PLAN COMMISSION

May 8, 2018
6:00 P.M.

- b. PLAN REVIEW – Review site, building, landscaping, and lighting plans submitted by Jacob Odders, Lakeshore Veterinary Specialists, for an emergency veterinary hospital on the property at 9472 S. 27th St. (Tax Key No. 878-9000-001). Follow this item on Twitter **@OakCreekPC#OCPCLakeshore**.

PLAN COMMISSION REPORT

LSP1.1 (Landscape Plan)

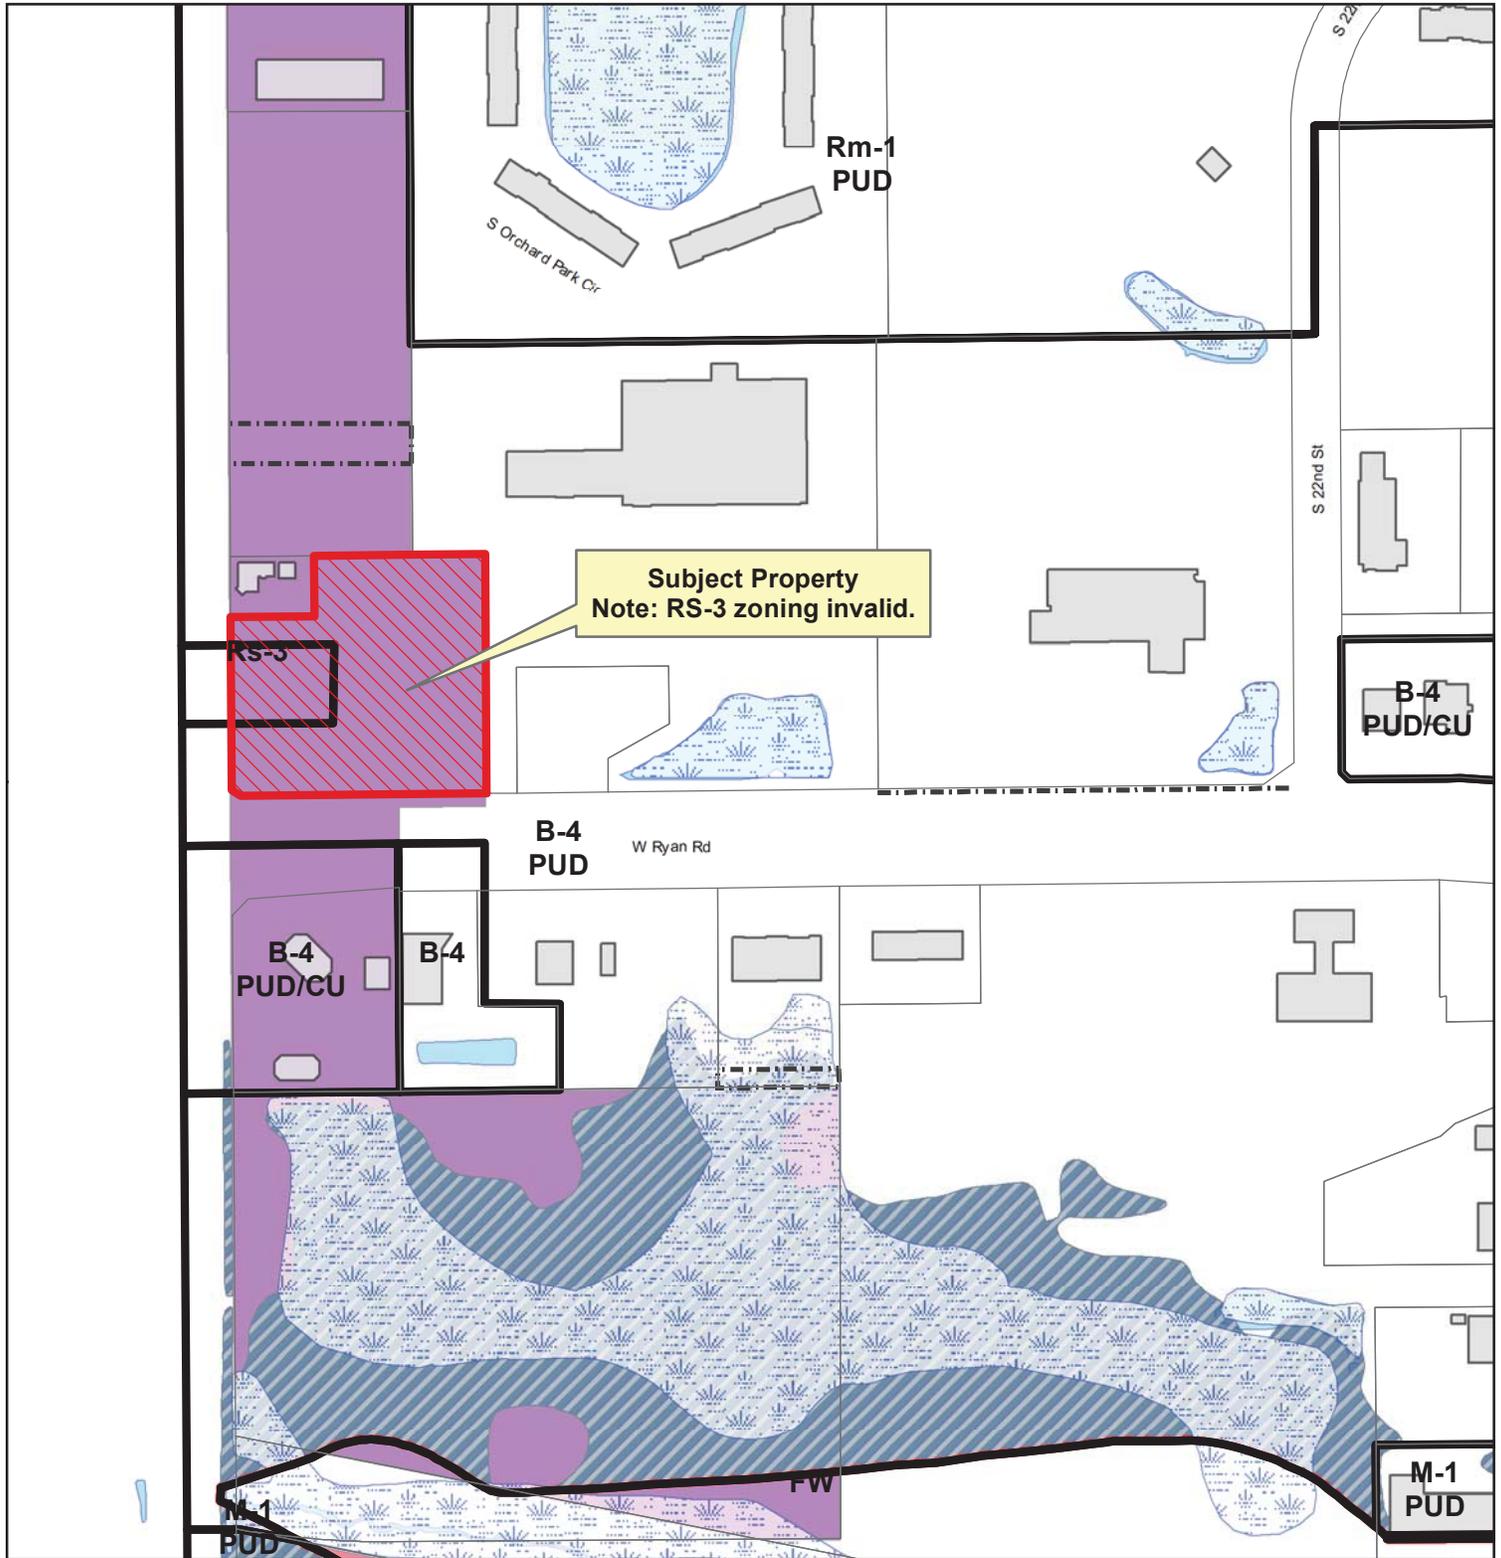
5. That the landscape plan is revised to include the heights of plants both at installation and maturity. Plants used to screen parking areas from rights-of-way must be installed and maintained at a minimum height of 3 feet.

1 SITE PLAN
SCALE: 1" = 30'-0"

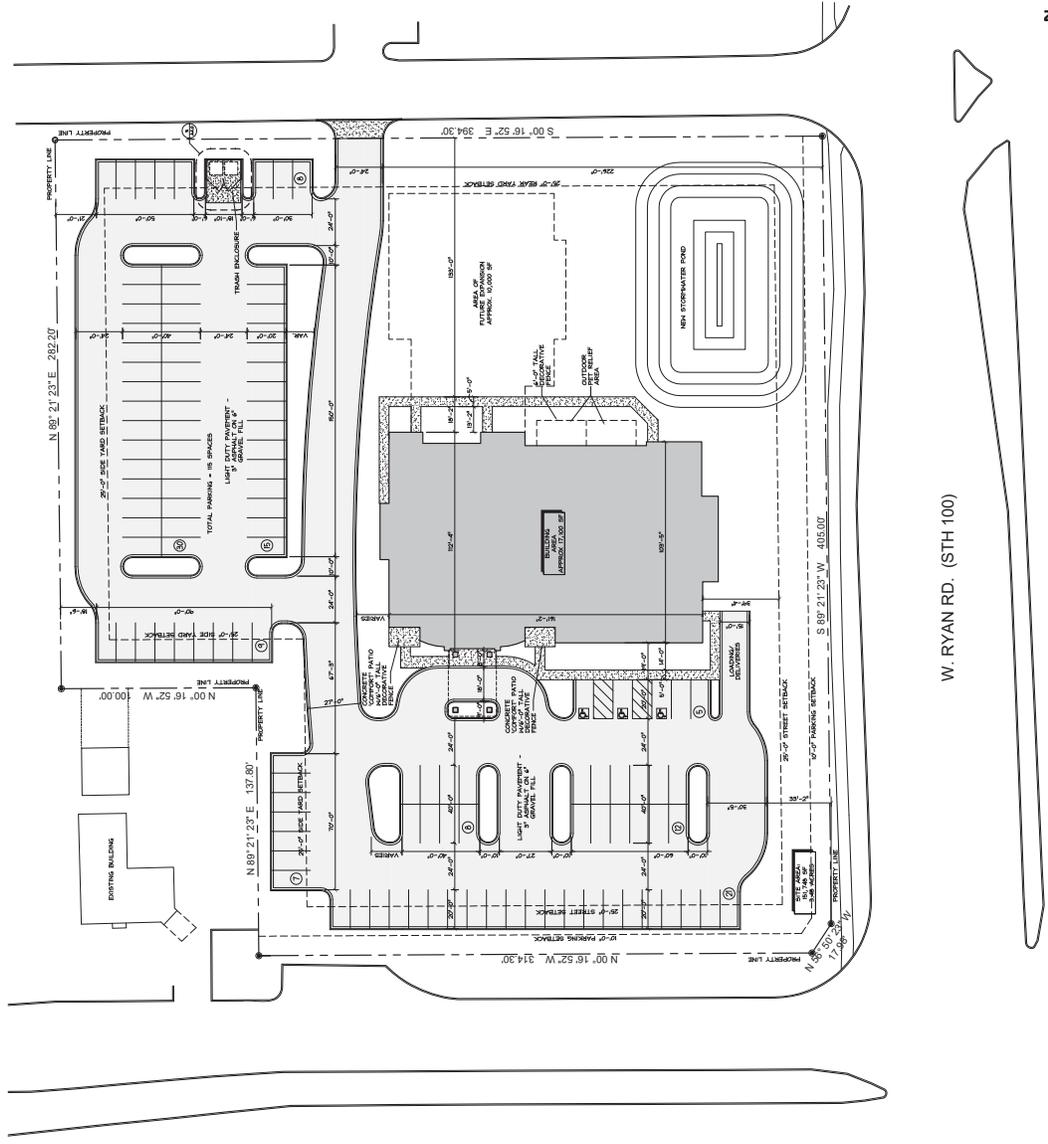
As proposed, the lot, building, and parking areas meet all dimensional requirements, including requirements for corner lots. Access is proposed via the shared easement to the east off of Ryan Rd. Staff has confirmed that this easement was required to be shared by WisDOT as part of an overall 27th Street access plan. Future access to 27th Street will be required by WisDOT to be shared by several properties, including the properties at 9430 and 9472 S. 27th St.

Parking was reviewed as part of the Conditional Use Permit request; however, there have been several changes:

1. Areas designated as “future parking” on the conceptual site plan are now shown to be constructed with this building.
2. The configuration of the access drive and parking areas has slightly changed.
3. The parking area to the east of the proposed building has been removed.
4. A total of 89 parking stalls were to be constructed, which is an excess of 5 stalls per Code based on 12 doctors and 48 staff. This proposed plan calls for a total of 115 stalls to be constructed, which is an excess of 16 stalls based on 17 doctors and 48 staff. New information provided in the narrative

One 22' 10" x 19' 0" trash enclosure is proposed in the northeast portion of the parking area. Proposed materials include brick veneer to match the building and a painted cedar plank gate (facing west). As with other trash enclosure proposals, staff recommends utilizing a more durable material such as composite for the gate. Landscaping is proposed in the islands immediately around the enclosure, and will be fully screened from the property to the east. Extensive landscaping is proposed throughout the site, with drifts on the northwest and southwest corners, wrapping around the south along a portion of Ryan Rd. Per Code, the landscape plan must include the heights of plants both at installation and maturity. Plants used to screen parking areas from rights-of-way must be installed and maintained at a minimum height of 3 feet. These requirements have been incorporated into the recommended conditions of approval above.

1 FIRST FLOOR PLAN
SCALE: 1/8" = 1'-0" AREA = APPROX. 17,500 SF

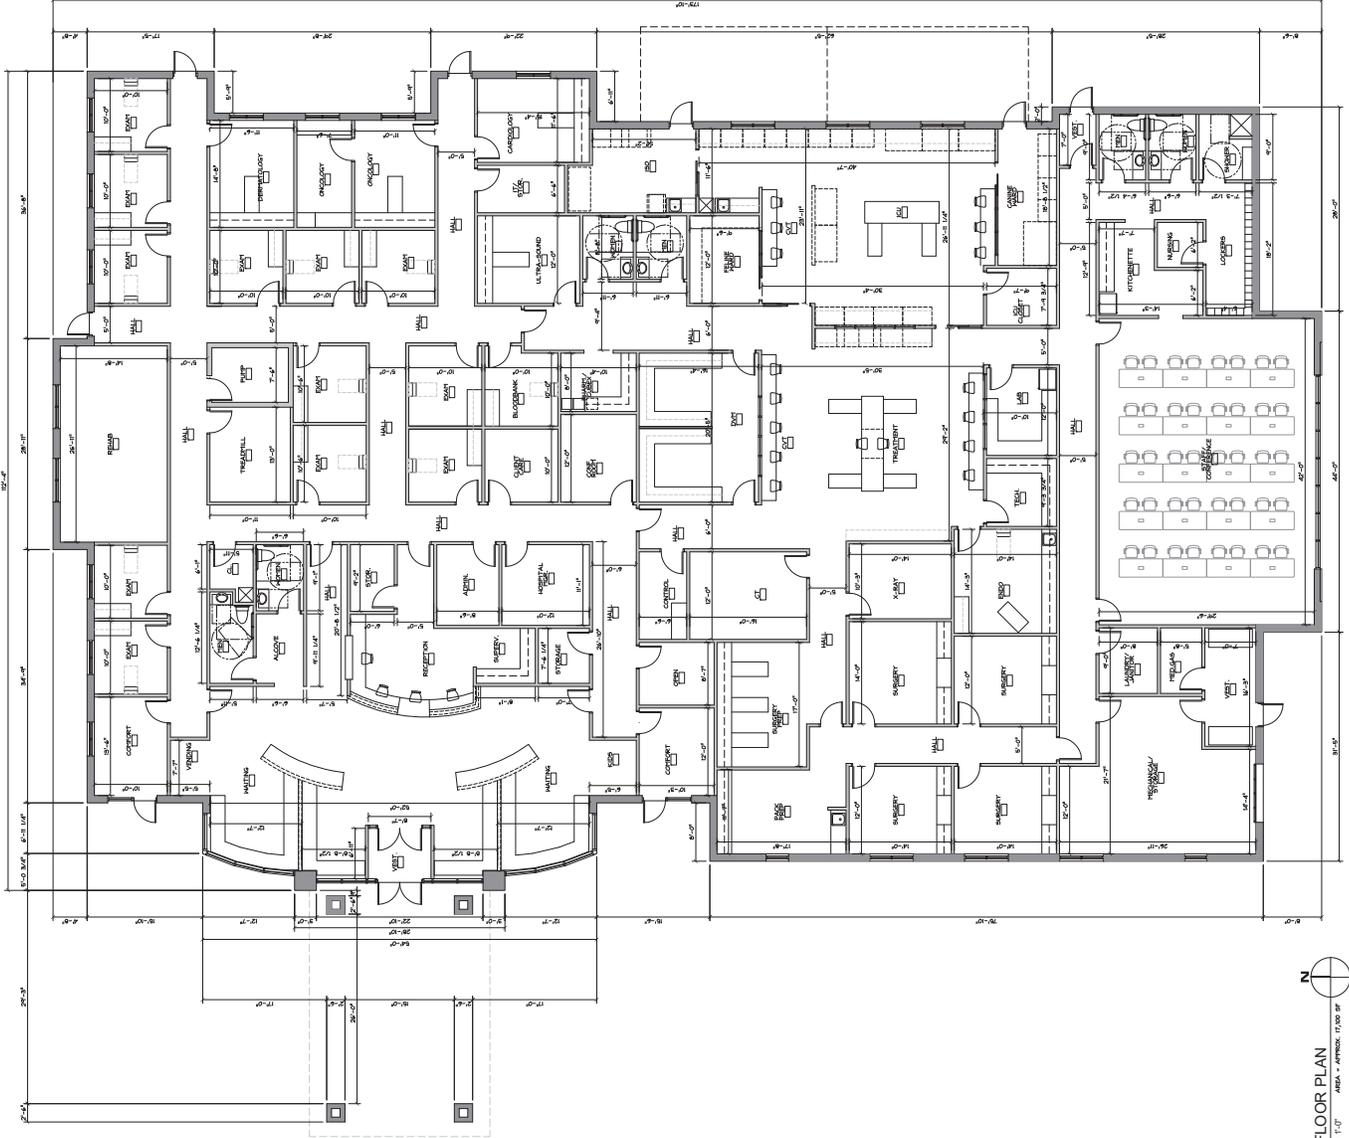
4. That the plans are revised to include locations for all mechanicals, transformers, and utilities. That all mechanical equipment, transformers, and utility boxes (ground, building, and rooftop) are screened from view.
